ARKANSAS NUCLEAR ONE - UNIT 1

IMPROVED TECHNICAL SPECIFICATIONS SUBMITTAL

**05/01/01 Supplement
Volume 2 of 2
(Sections 3.7 and 3.8)**

May 1, 2001

Figure 3.8.1

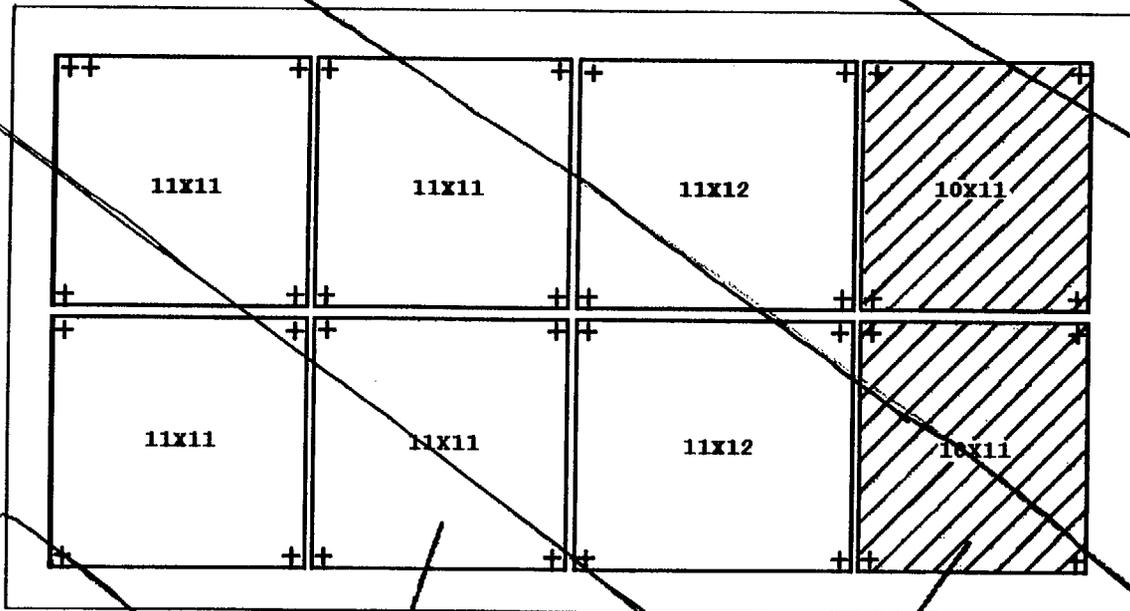
3.8.16 Storage in Region 2 ~~(as shown on Figure 3.8.1)~~ of the spent fuel pool shall be further restricted by burnup and enrichment limits specified in Figure 3.8.2. In the event a checkerboard storage configuration is deemed necessary for a portion of Region 2, vacant spaces adjacent to the faces of any fuel assembly which does not meet the Region 2 burnup criteria (non-restricted) shall be physically blocked before any such fuel assembly may be placed in Region 2. This will prevent inadvertent fuel assembly insertion into two adjacent storage locations. The provisions of Specification 3.0.3 are not applicable. (LA3) SAR

<u>CTS Location</u>	<u>New Location</u>
3.7-31 Figure 3.8.1	SAR Fig. 9-53
3.7-15 Table 4.1-3, #4 w/Note (9)	TRM
3.7-19 4.5.1.1.2 (b)	TRM
4.5.2.1.2 (c) (3)	TRM
3.7-21 4.11.5	TRM
